Federal Recall Information

11KWD

T660 Hood Strut Safety Latch

Fig. 1

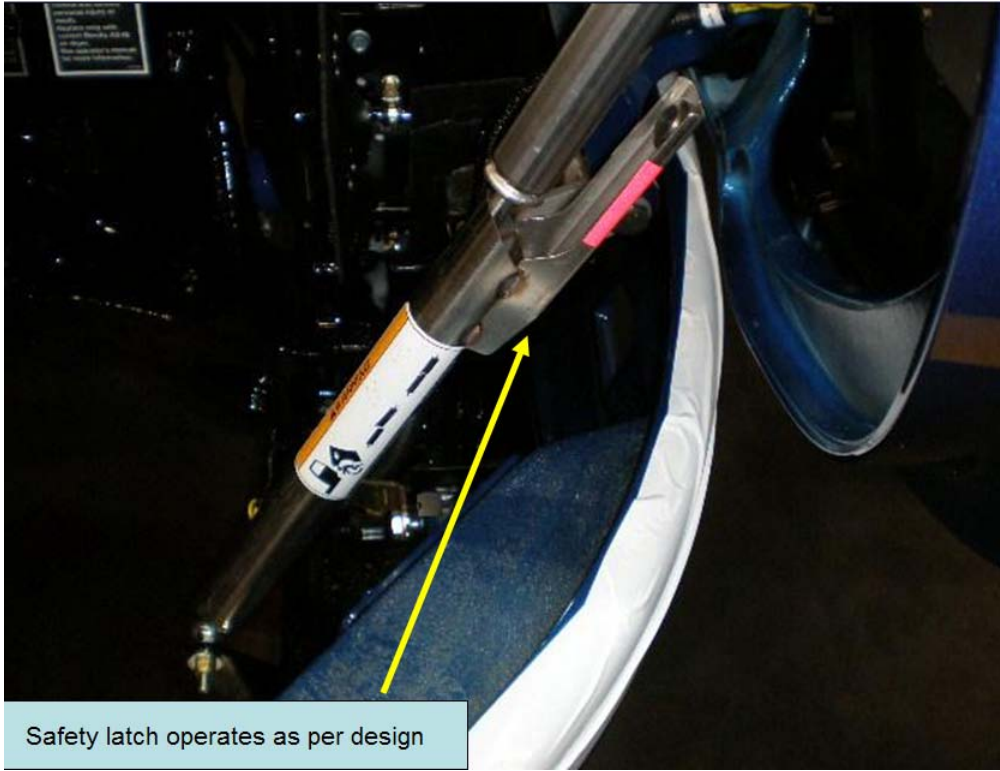
In normal operation the safety latch feature is automatically set and prevents the hood from closing (ref. Figure 1). If the hood strut were to separate, the safety latch feature may not automatically set resulting in a non-operational safety latch feature when the hood is opened (ref. Figure 2). A non-operational safety latch feature may not be detected by an operator increasing the risk of personal injury and/or vehicle damage.

It has been determined that struts manufactured by ASR with a lot code of W010176 are affected by this recall.

The remedy of the recall will involve inspection of the strut for Lot # W010176 and replacement as appropriate. See Procedure below.

Fig. 3

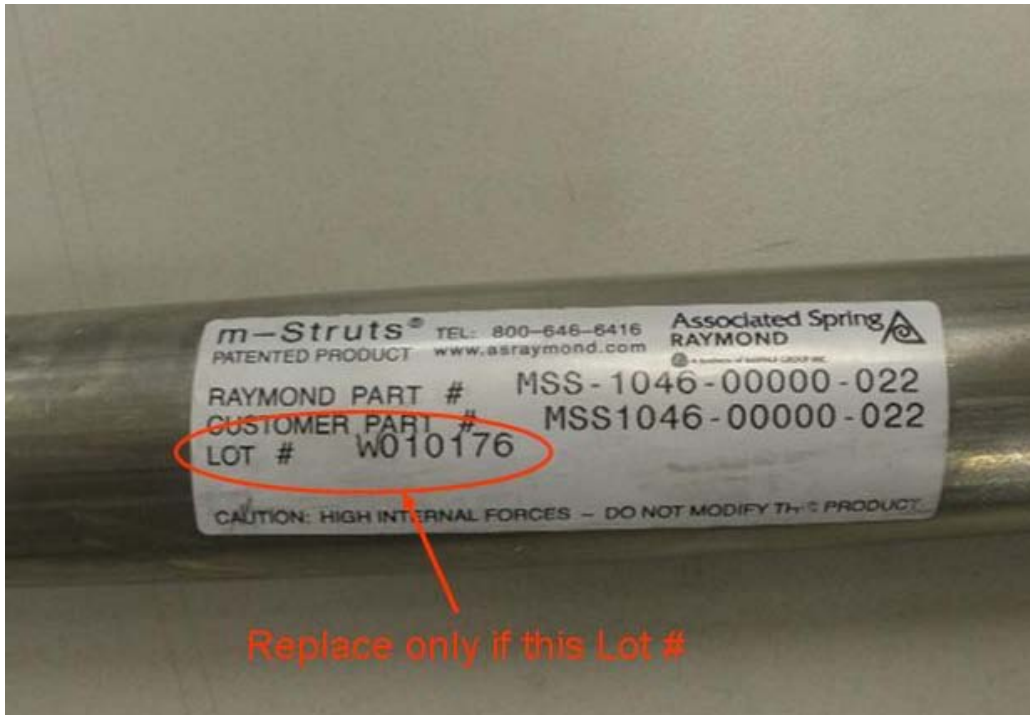
Inspect strut for Lot # W010176 (see Fig. 3 below), and replace ONLY if Lot # is W010176.
